TECHNICAL SERVICES BULLETIN

Document ID: 8-23-NA-35-004
Bulletin Title: VF8_Cabin Cooling Performance Increase rework
Released by: VF – GRSC
Date of issue: EN Version 1.0 / 22 May 2023
Applies to: VF Aftersales, Dealers and Showrooms

Market	US & CANADA
Applicability	The Purpose of this bulletin is to instruct & perform a rework at Port PDI and Dealer/Service center for the VF8 model – to increase the cooling performance inside the cabin

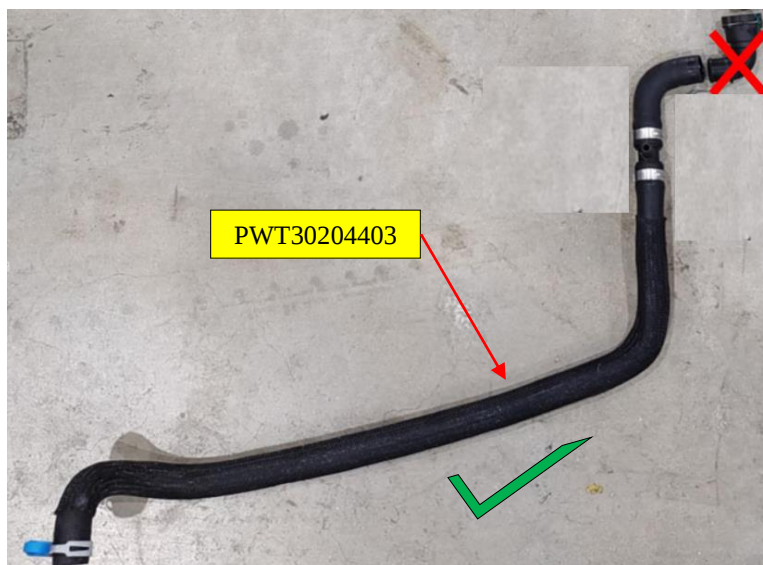
- i. Remove & secure the hose and clamp from HOSE_PUMP_2_TO_BATTERY_CHILLER as shown in below figure [Part Number: PWT30204307] & discard the remaining part.

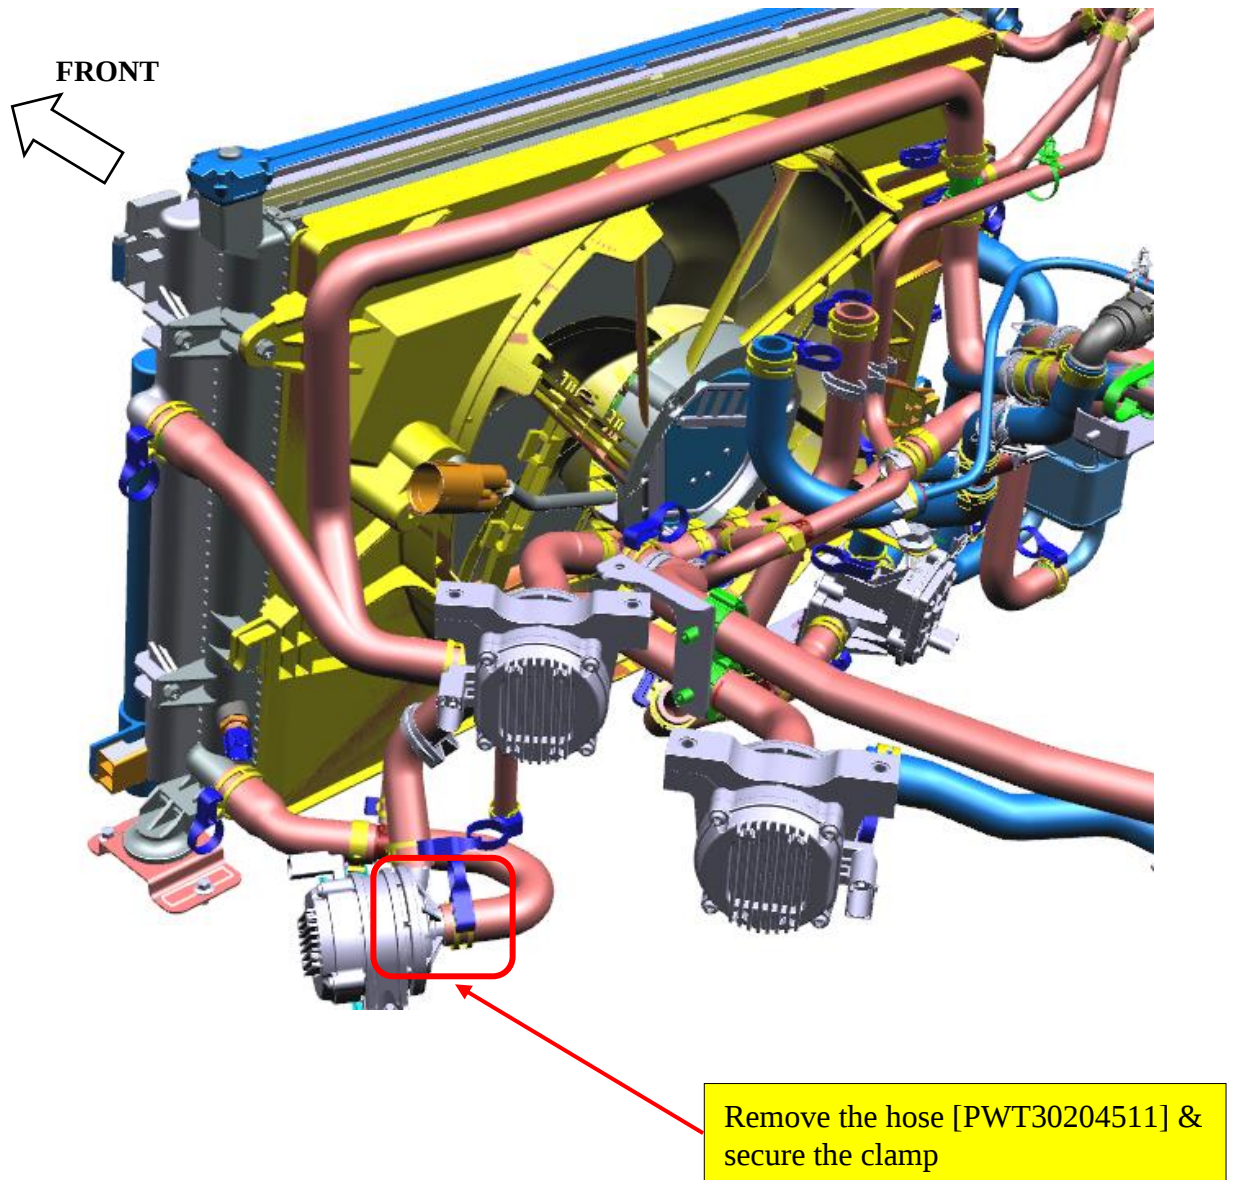
- i. Remove the hose EDS-RADIATOR_TO_PUMP4_HOSE (PWT30204511) from the pump4 and drain the coolant [collect coolant in the storage tank for reuse].
- ii. Secure the removed clamp [size: 27] for reuse at later steps

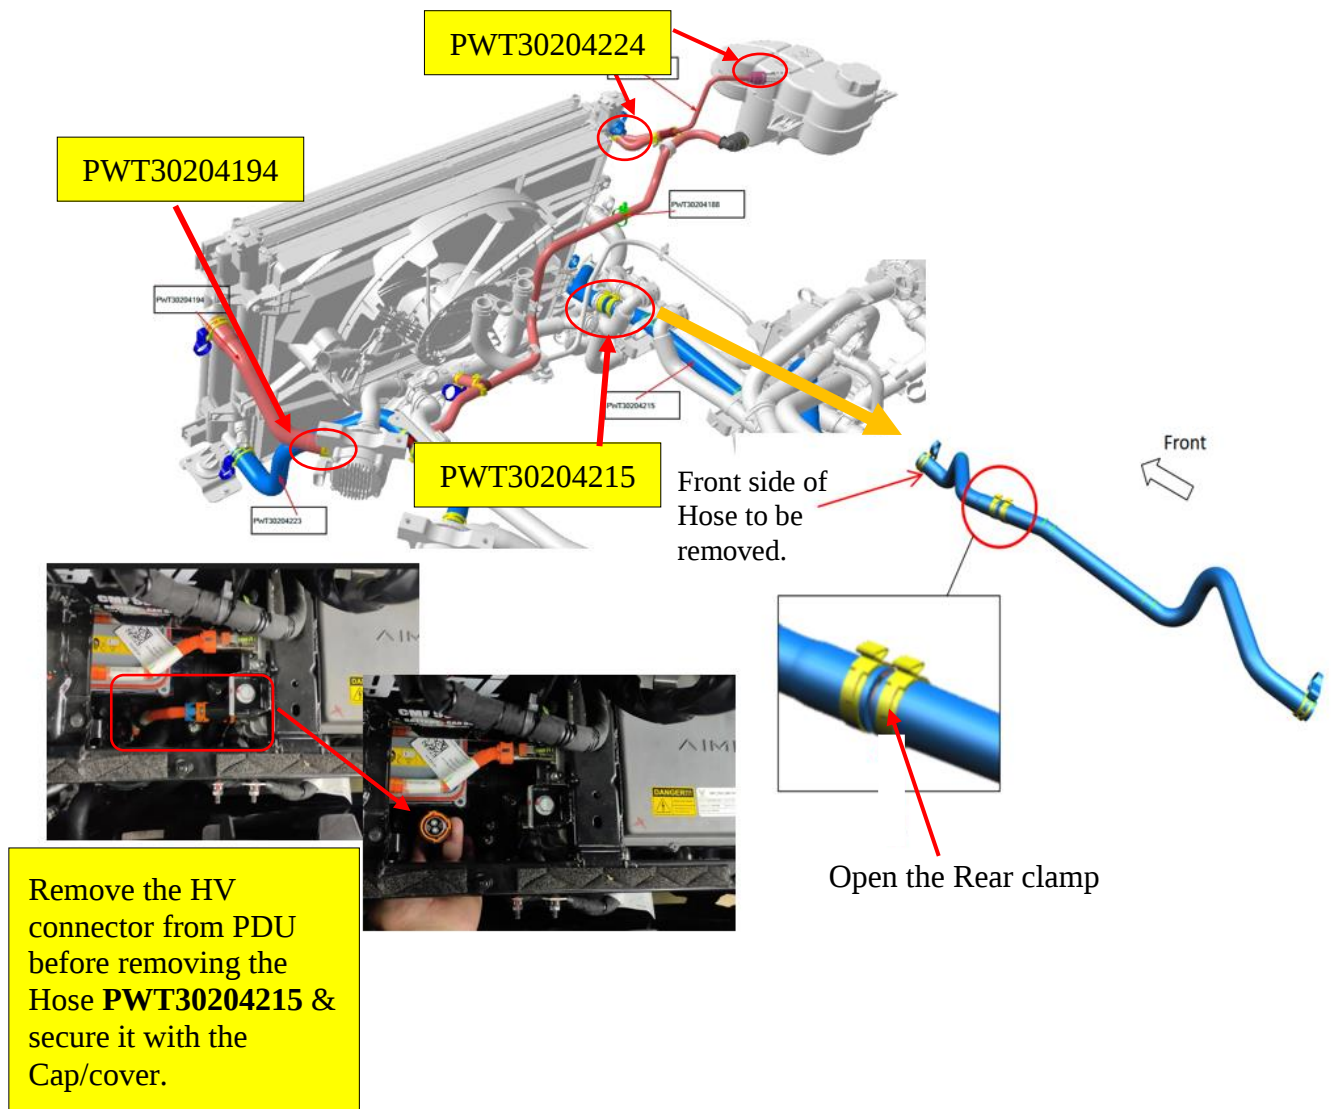
- i. Lift down the car and remove the three hoses from the vehicle as shown in below figure and discard it.

Attention: Remove the HV connector from PDU before removing the Hose **PWT30204215** & secure it with the cover as shown in below figure

SNo	Part Number	Part Name	Remark
1	PWT30204224	RAD_VENT_HOSE_SFC	Expansion Tank venting to radiator venting hose
2	PWT30204215	CHILLER_INLET_HOSE_SFC	Battery Chiller to radiator
3	PWT30204194	BATT_RAD_INLET_HOSE	Water pump to radiator

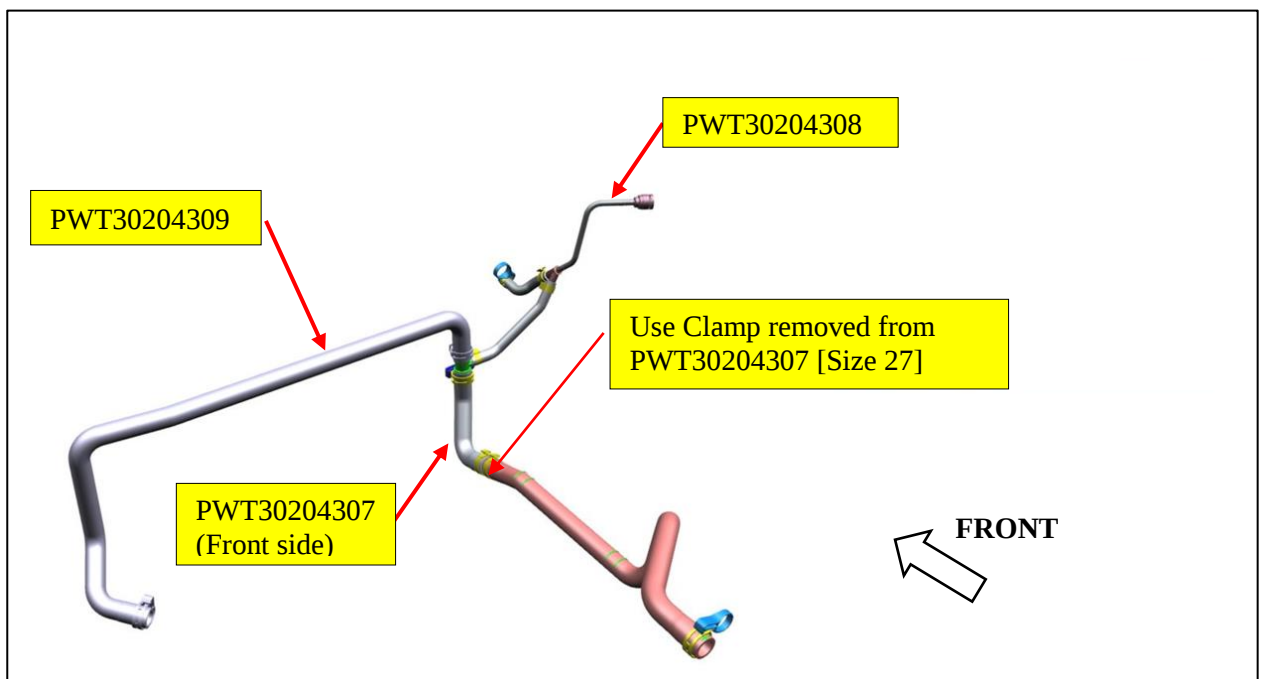
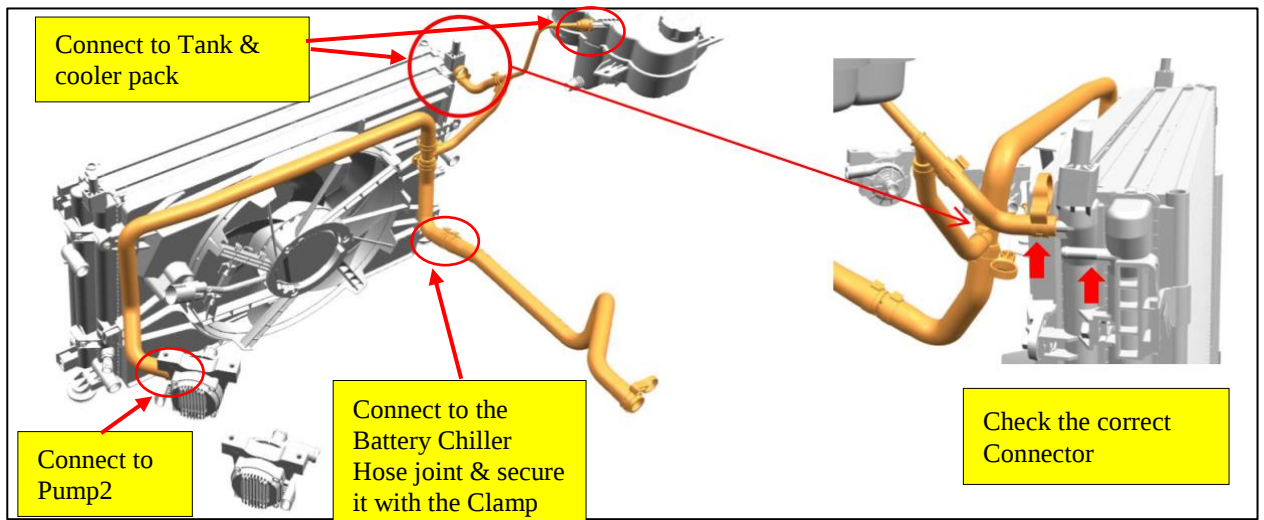
- i. Connect the Hoses PWT30204307, PWT30204308 & PWT30204309 as shown in below figure.

- Connect the HV connector with PDU after installing the hoses.
- Check for clamp size 27 & mark in the clamp for fixing the hose [PWT30204307].

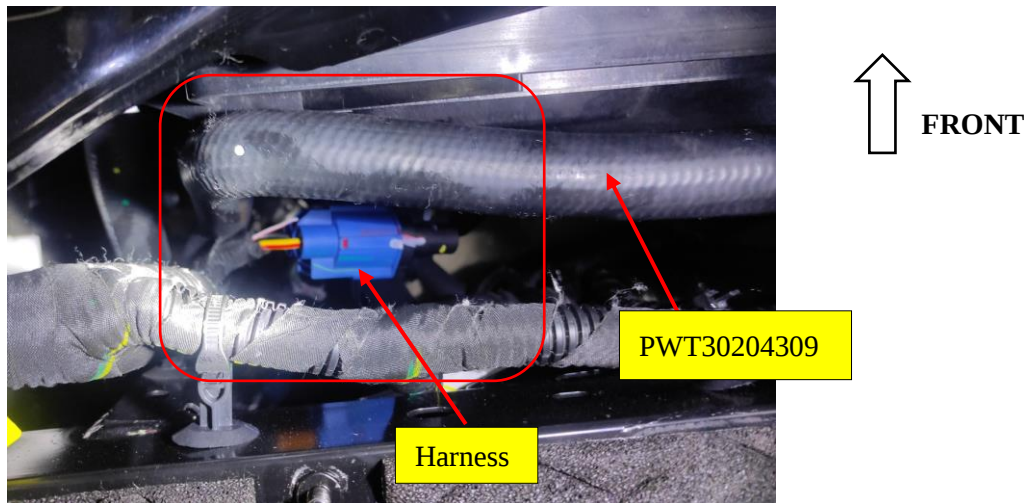
- ii. Before connecting the hose [PWT30204309] to Pump2, ensure the hose routing towards vehicle outside & wiring harness with connector towards vehicle inside

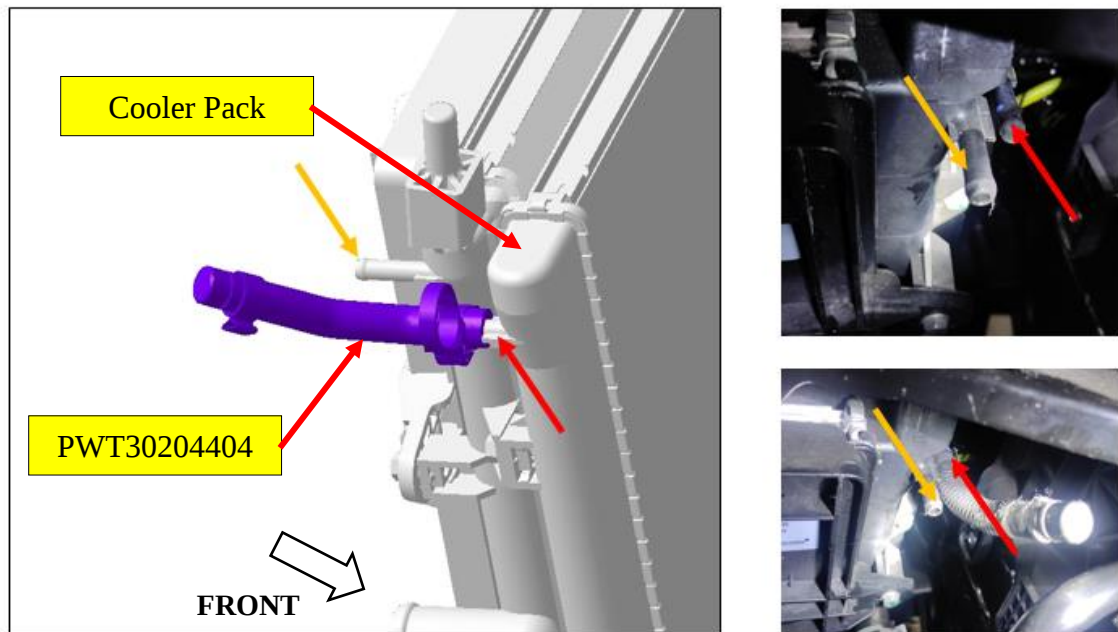
- i. Connect the HOSE-BATTERY_VENTING_BLOCK as shown in below figure.
[Part Number: PWT30204404]

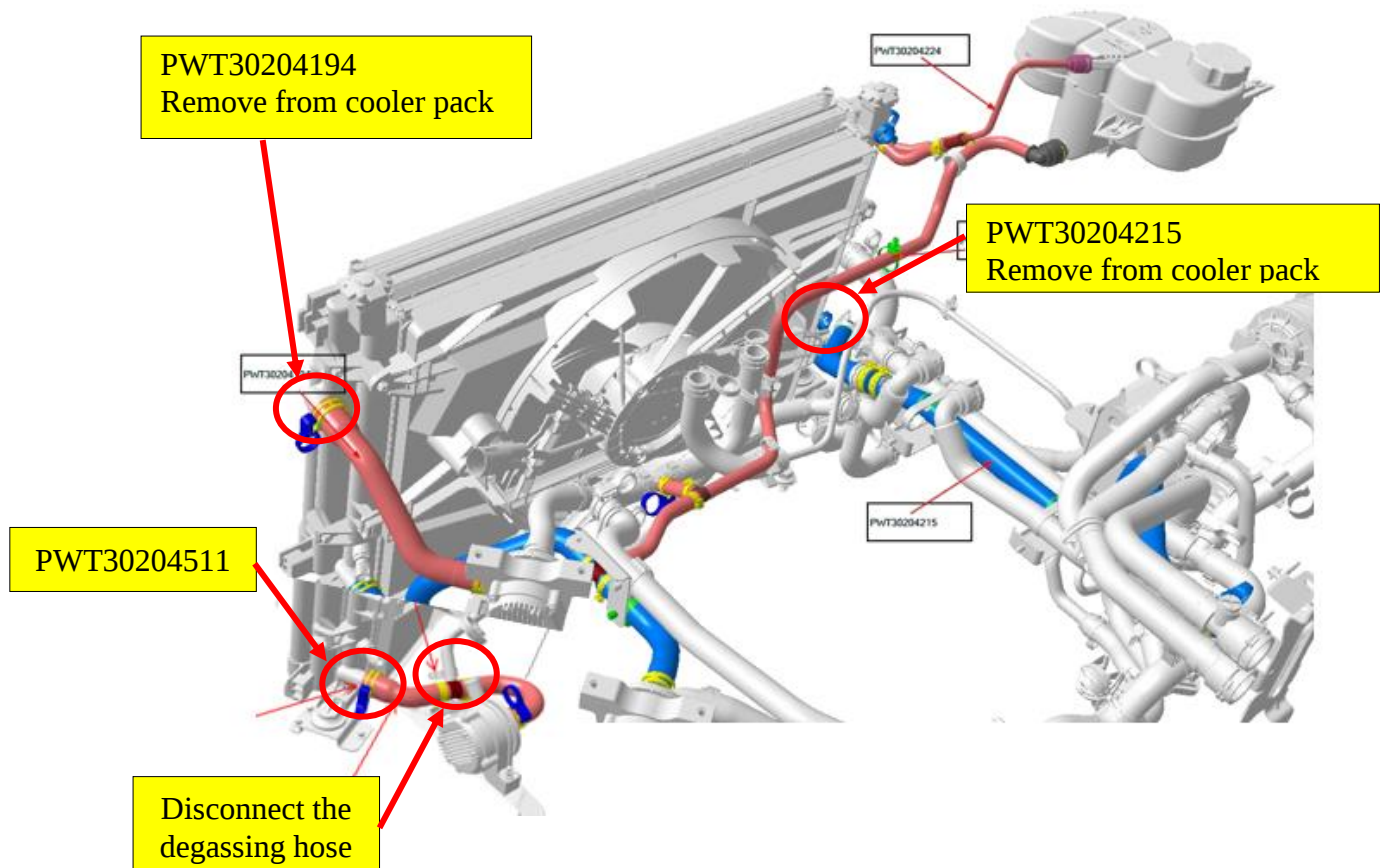
- i. Lift-up the car & remove connection hoses [PWT30204194, PWT30204215 & PWT30204511] from the vehicle as shown in below figure, and discard it.

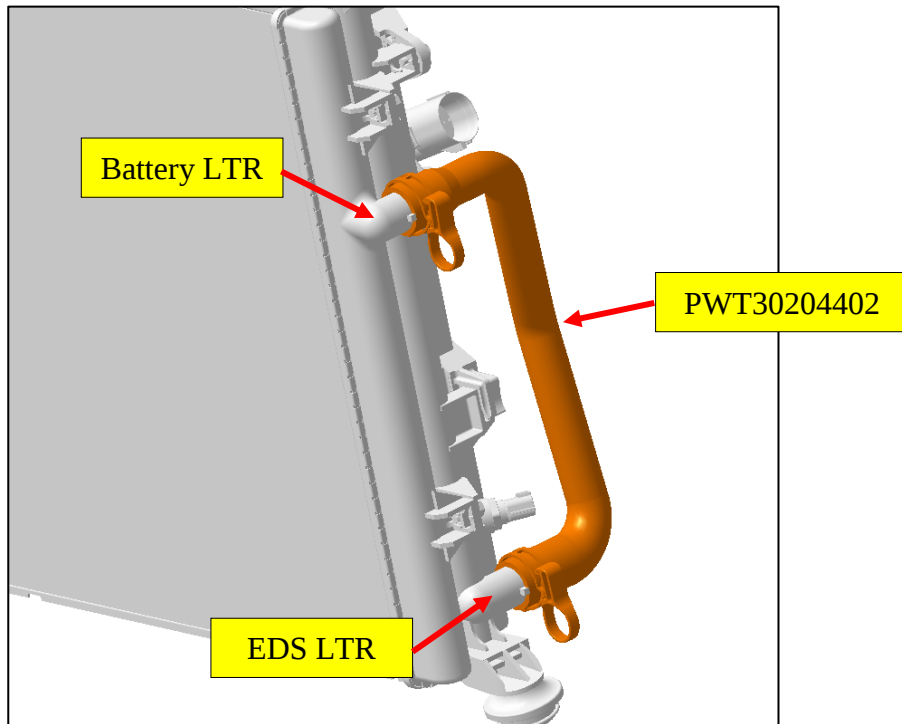
- ii. Connect the HOSE_EDS_LTR_TO_BATTERY_LTR as shown in below figure.
[Part Number: PWT30204402]

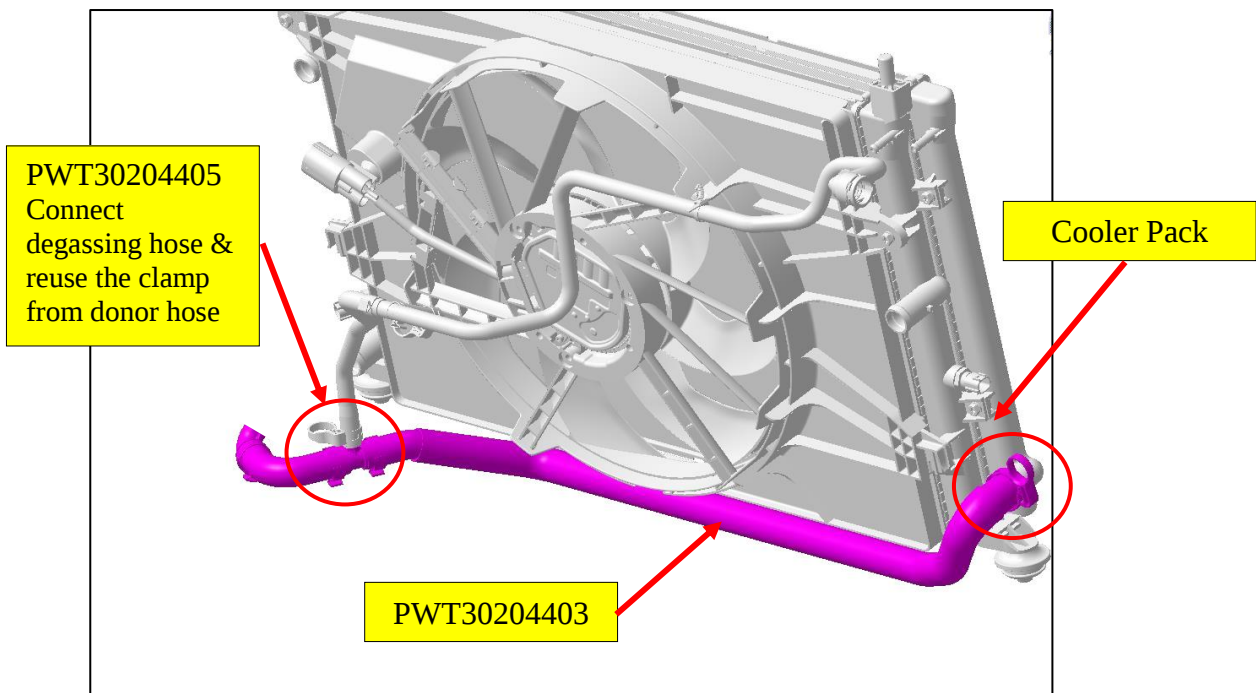
- iii. Connect the HOSE_BATTERY_LTR_TO_PUMP_4 to Cooler Pack as shown in below figure.
[Part Number: PWT30204403]

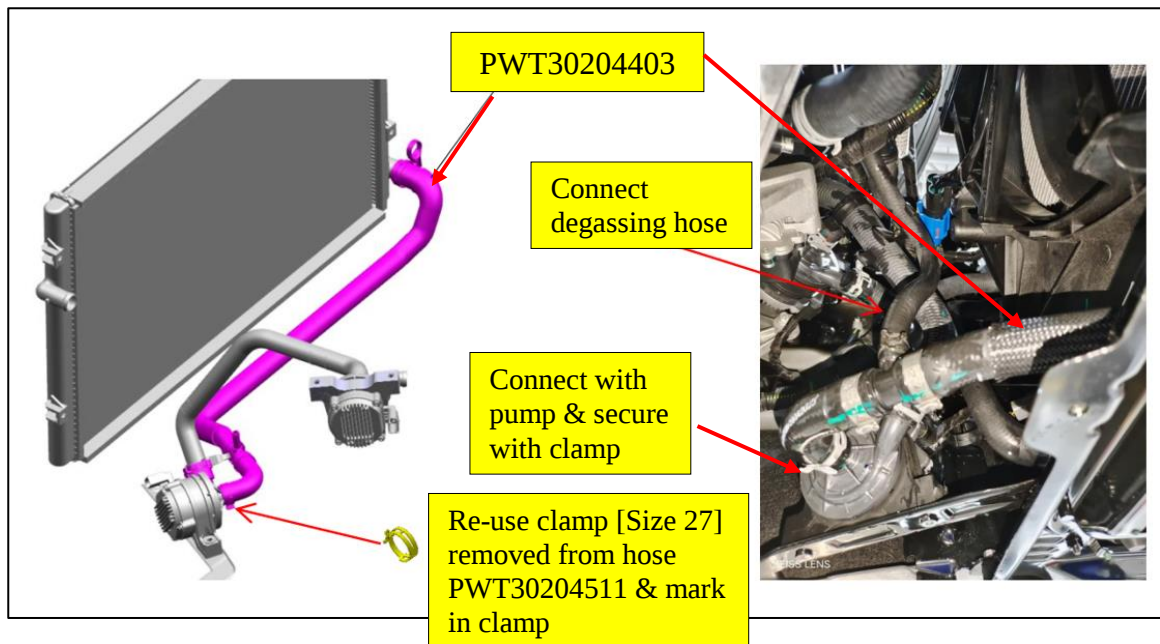
- iv. Connect the HOSE_BATTERY_LTR_TO_PUMP_4 to pump as shown in below figure.
[Part Number: PWT30204403]

Attention: Check for clamp size 27 & mark in the clamp for the hose [PWT30204403]

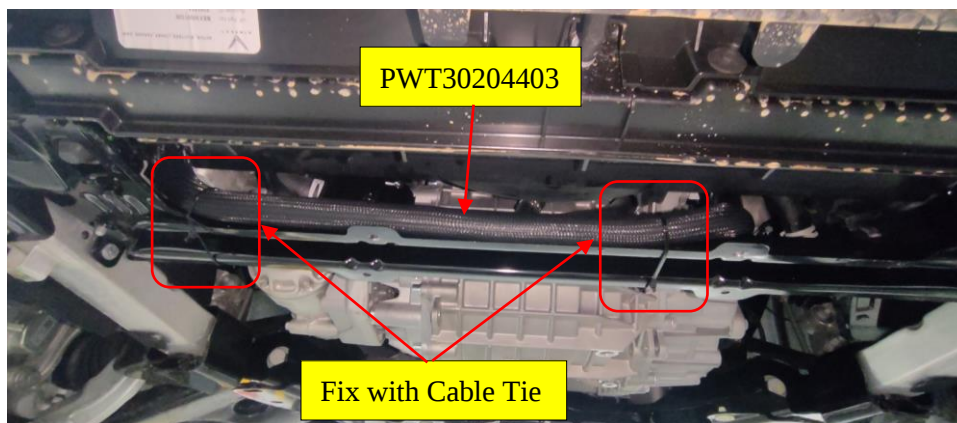
- i. Fix the hose [PWT30204403] with two cable ties as shown in below figure.

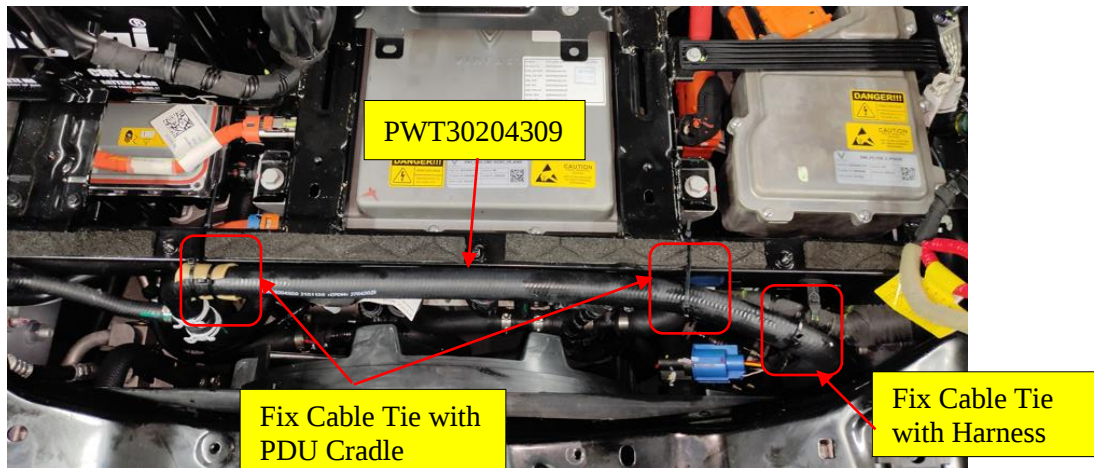
- iii. Lift down the vehicle & fix the hose [PWT30204309] with three cable ties as shown in below figure.
